AEP:NRC:4321
10 CFR 50

SUBJECT: Donald C. Cook Nuclear Plant Units 1 and 2
Docket Nos. 50-315 and 50-316
Degraded Voltage Protection at Donald C. Cook Nuclear Plant

Response to U. S. Nuclear Regulatory Commission Request Regarding Degraded Voltage Protection

One Line Electrical Diagram – Donald C. Cook Nuclear Power Plant

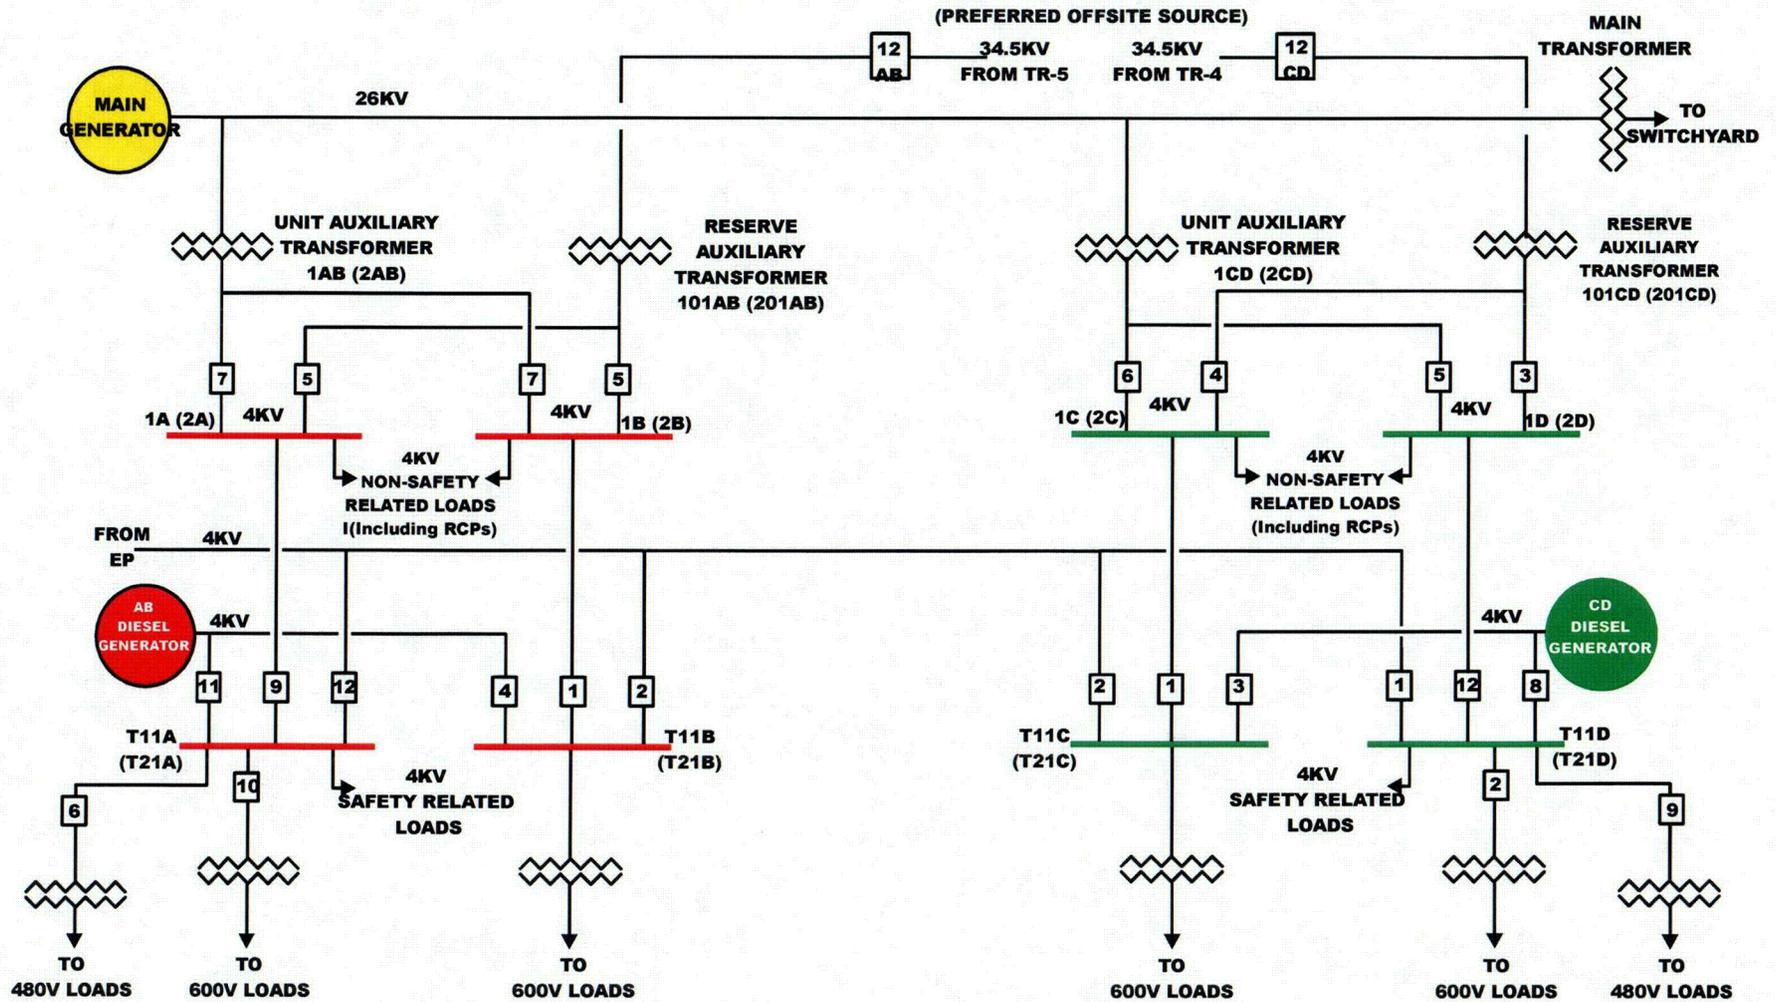
During normal operation potential degraded voltage conditions existing on redundant safety-related buses will not be automatically detected.

With the degraded voltage protection bypassed, the potential exists for disabling redundant equipment important to safety if degraded voltage conditions exist. Under these conditions, the existing design may also result in rendering both offsite and onsite power sources unusable.

If degraded voltage protection is bypassed for the first 30 seconds of an accident and a sustained degraded offsite power condition exists, the permanently connected Class 1E loads (e.g., magnetic contactors for the motor operated valves) may be damaged and may prevent the associated motors from performing their safety functions.

Attachment 2 to this letter provides a simplified one-line diagram showing portions of the offsite and onsite electrical power systems involved in degraded voltage protection at CNP. In the following descriptions, the Unit 1 component numbers are stated followed by the corresponding Unit 2 component numbers in parentheses.

During normal plant operation (i.e., main generator supplying power to the transmission network), the 4 kilovolt (kV) non-safety buses 1A, 1B, 1C, and 1D (2A, 2B, 2C, and 2D) are powered from the main generator via the Unit Auxiliary Transformers (UATs) TR1AB and TR1CD (TR2AB and TR2CD). This configuration was acknowledged by the NRC in the safety evaluation (SE) for initial plant licensing (Reference 1). The 4 kV non-safety buses provide power to safety-related 4 kV buses T11A, T11B, T11C, and T11D (T21A, T21B, T21C, and T21D). In this configuration, the non-safety and safety-related 4 kV bus voltages are automatically controlled by the main generator voltage regulator through the UATs. Since the main generator voltage regulator automatically responds as needed to support nominal voltage on the transmission network, 4 kV bus voltage variations are opposite from those occurring on the offsite circuit, which is supplied by the transmission network. Therefore, due to the impedance of the main transformer, when the offsite voltage is below nominal, the main generator voltage will be above nominal, which will result in above nominal voltages on the 4 kV and lower tier buses.

As described in Section 3.0 above, during normal operation when the 4 kV buses are supplied by the UATs, bus voltages are monitored at the 4 kV and 600 V levels. Upon detection of a degraded voltage, a control room annunciator actuates. Therefore, degraded voltage conditions existing on redundant safety buses will be automatically detected.

The current CNP design and operational provisions assure that equipment important to safety is not disabled due to degraded voltage during normal operation. As described in Section 3.0 above, the main generator voltage regulator automatically maintains the desired voltage during normal operation. Instrumentation continuously monitors voltages at the 4 kV and 600 V levels during normal operation, and operator actions to correct an unacceptable voltage are initiated in accordance with established annunciator response procedures. I&M considers that a failure of operators to take action in response to the annunciators is not credible. There is a high degree of confidence that the procedurally prescribed action of raising the main generator output voltage will be successful in restoring the 4 kV and/or 600 V safety-related bus voltages to acceptable levels. These design and operational provisions assure that a degraded voltage condition that would disable equipment important to safety would not occur.
